PRELIMINARY STORMWATER SITE PLAN

Convenience Store with Gas

1402 South Meridian
Puyallup, Washington 98371

City File No. PLPSP20220079

Figure 5.2 Developed Basin Map

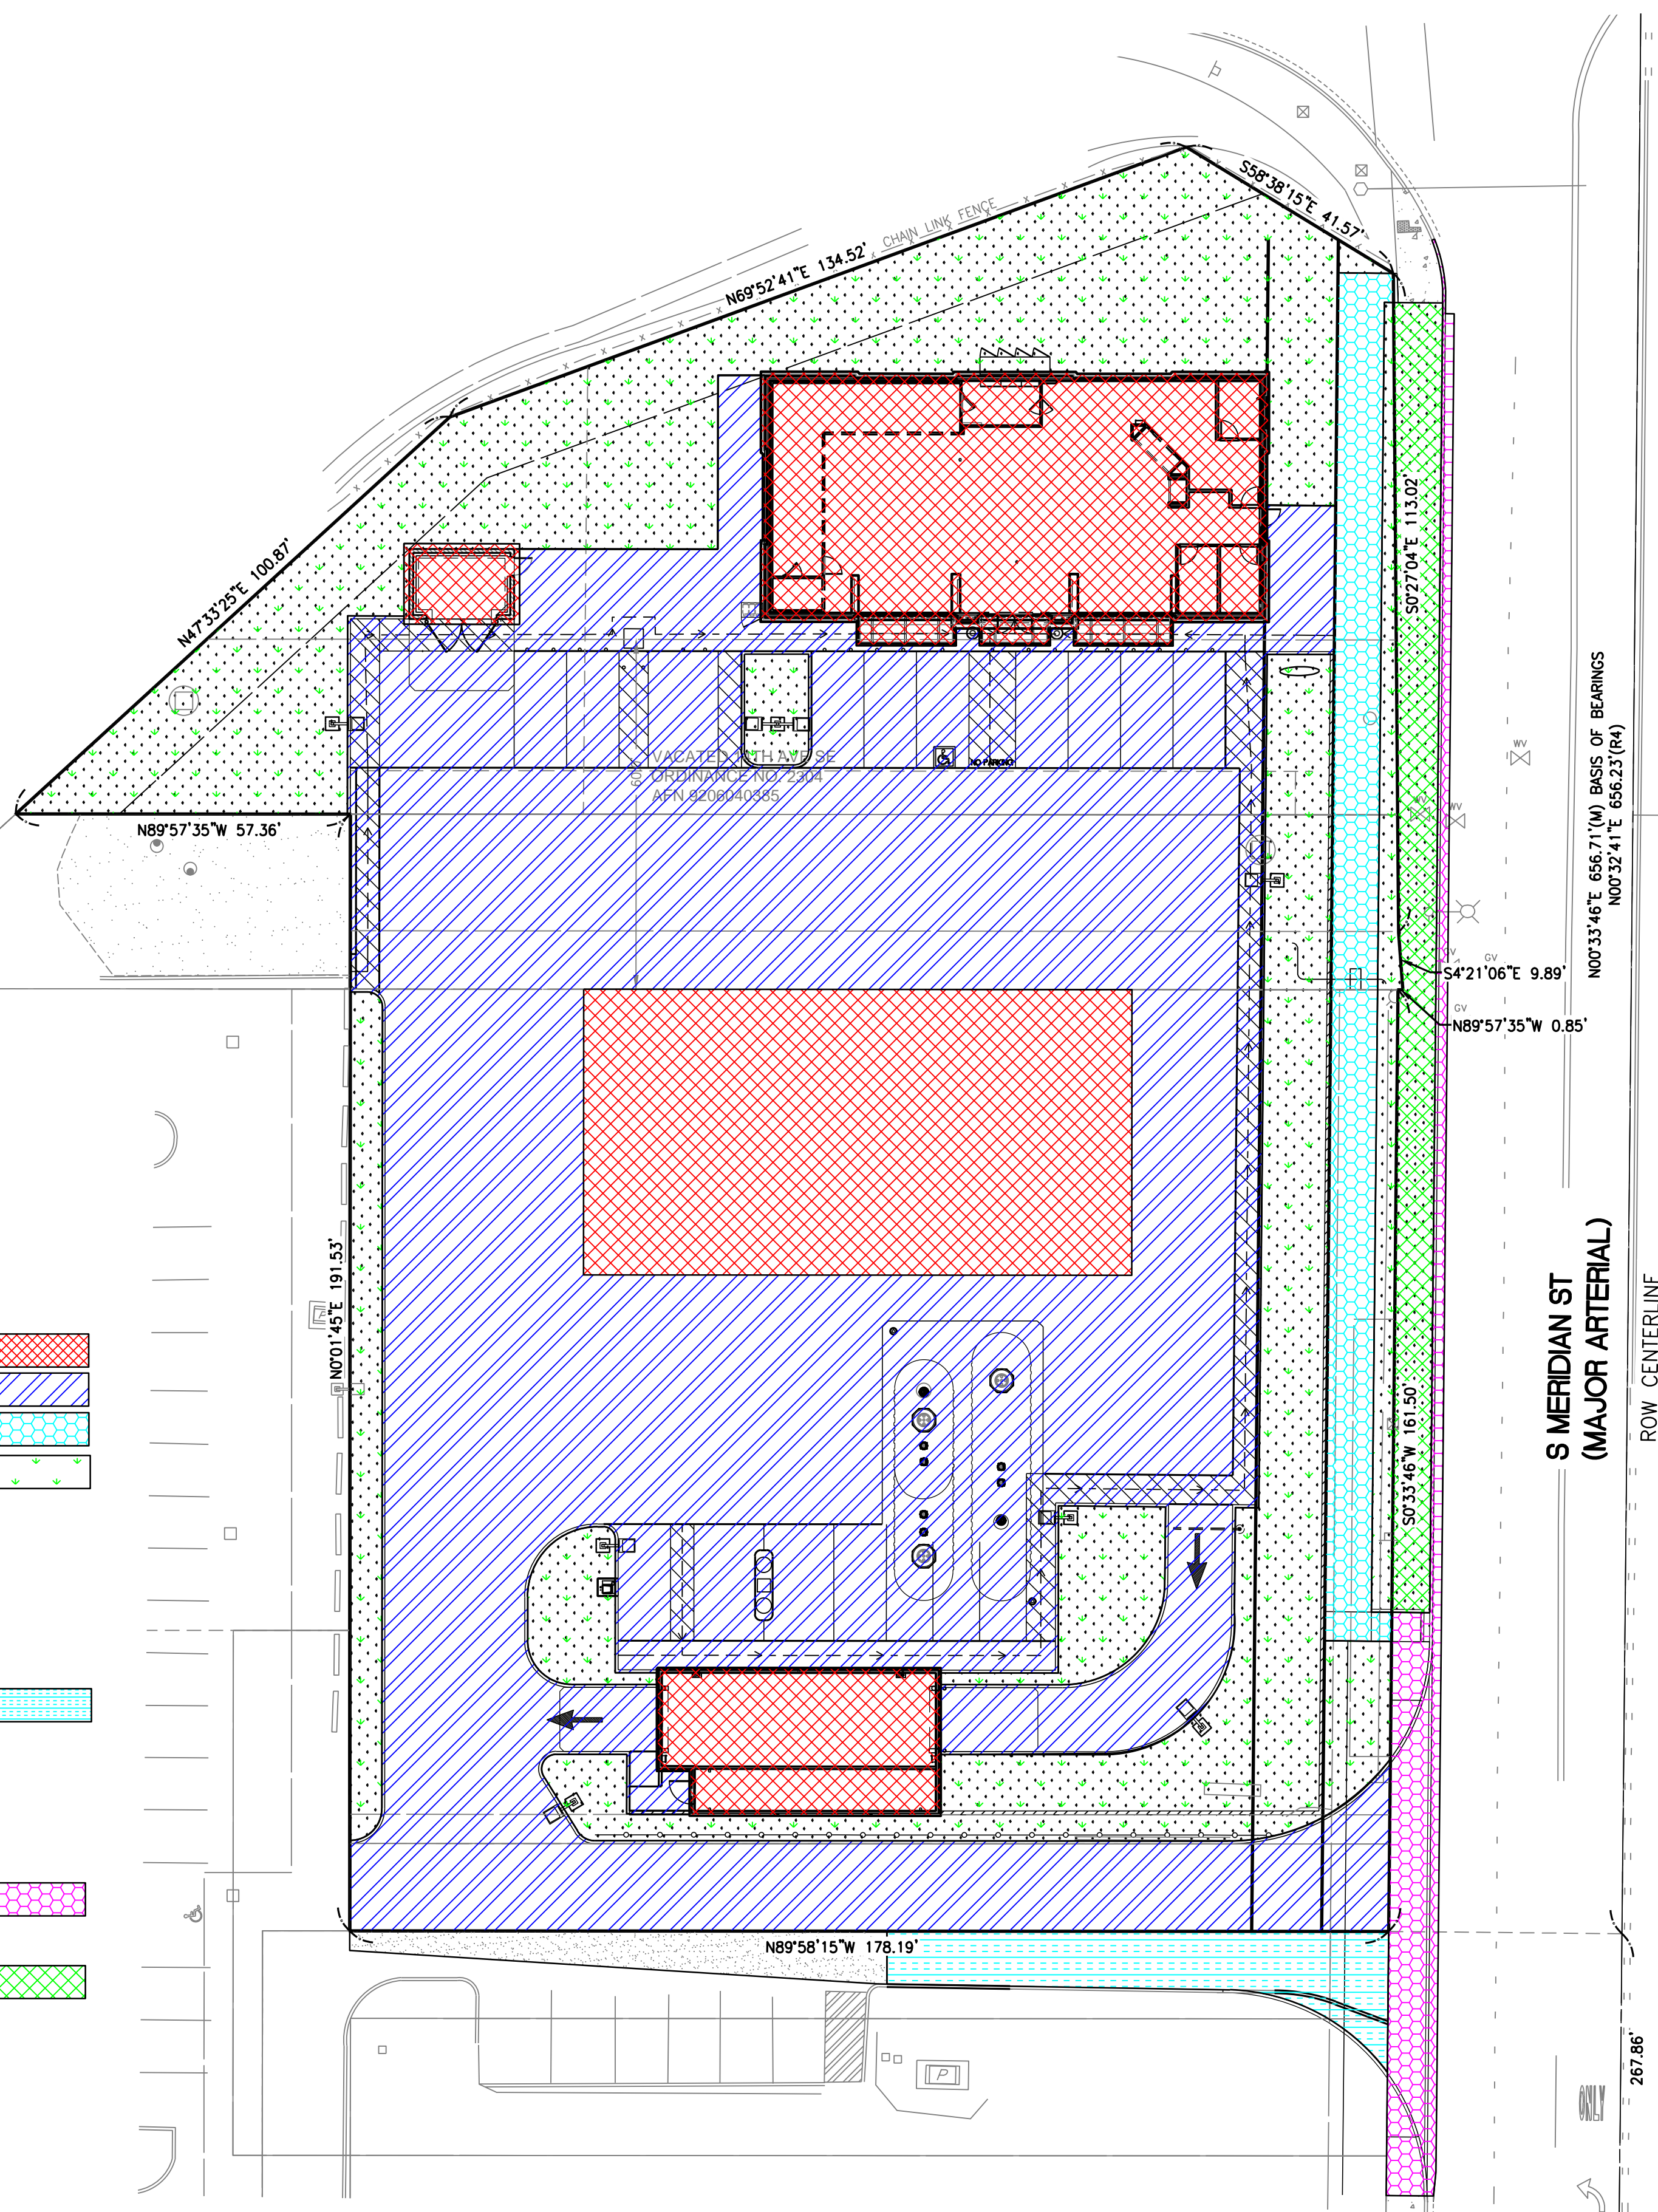
Include an additional map indicating Basin 1 vs Basin 2 (Bypass) [Drainage report, pg 34]

Mitigated Schematic

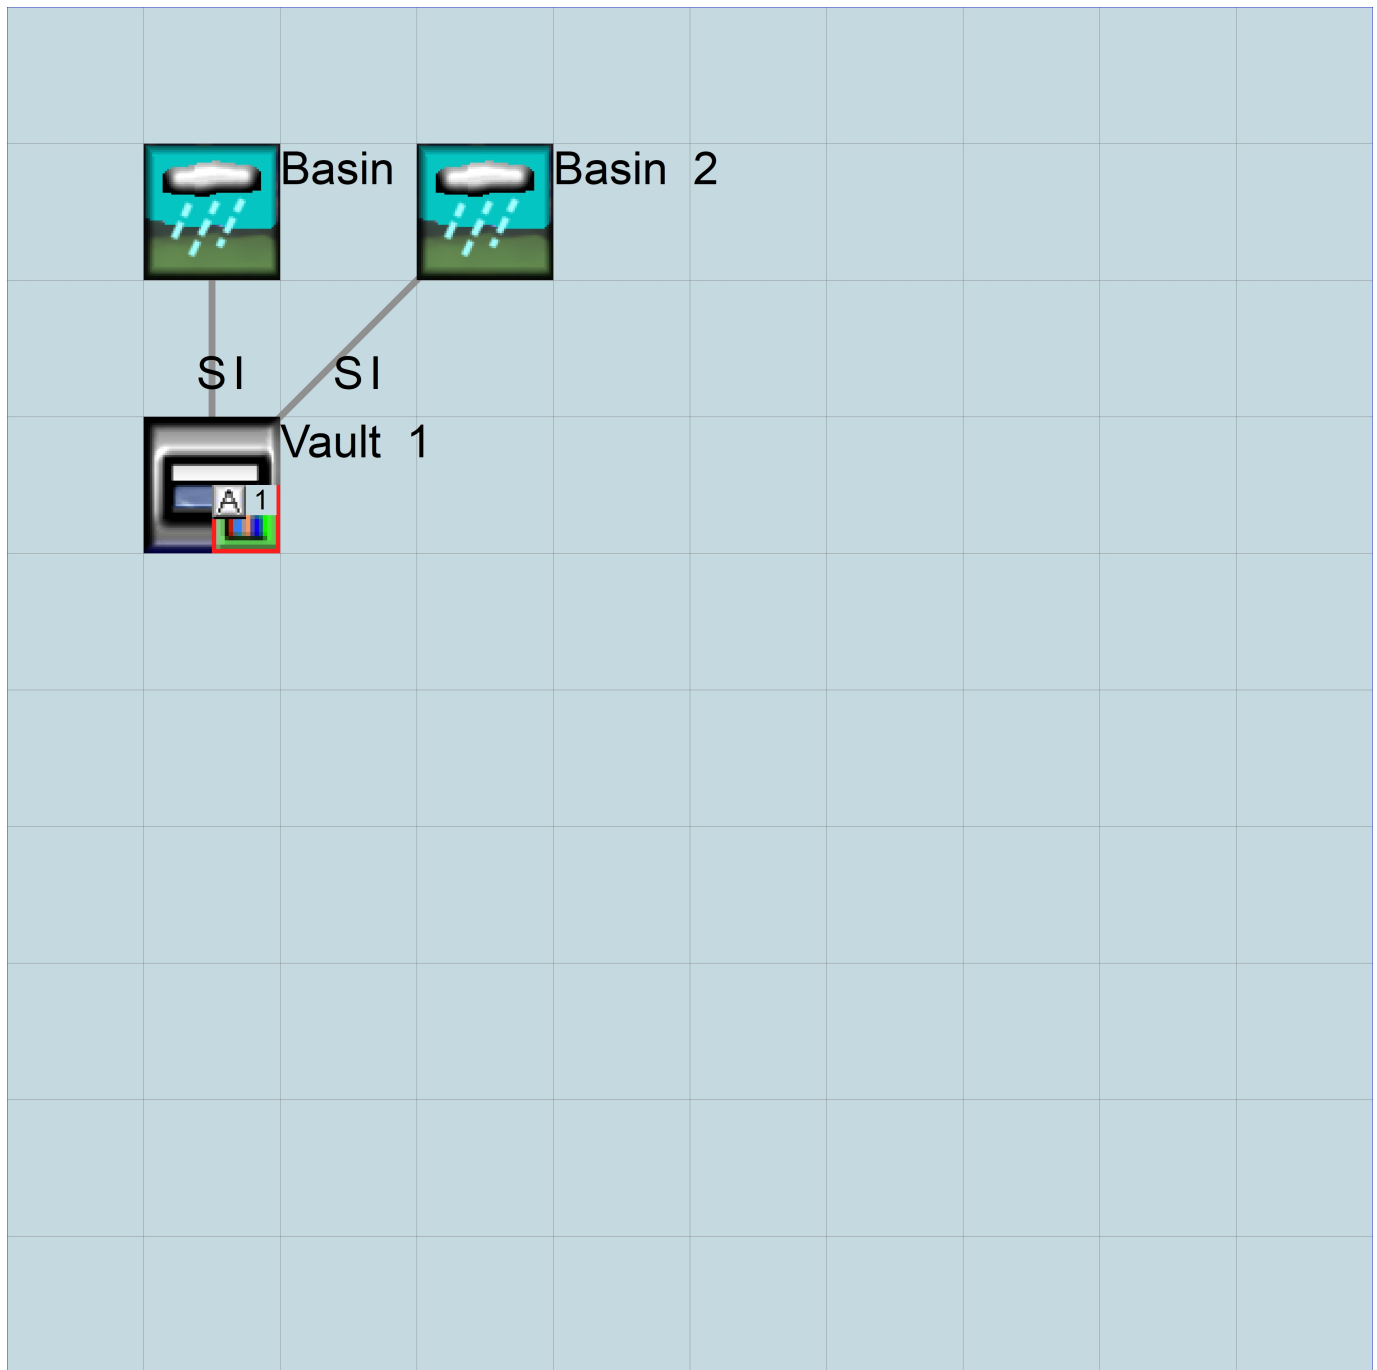
The pre-developed conditions do not show the existing impervious surfaces which will skew the WWHM results for the flow control calculation. Revise accordingly. [Drainage report, pg 45]
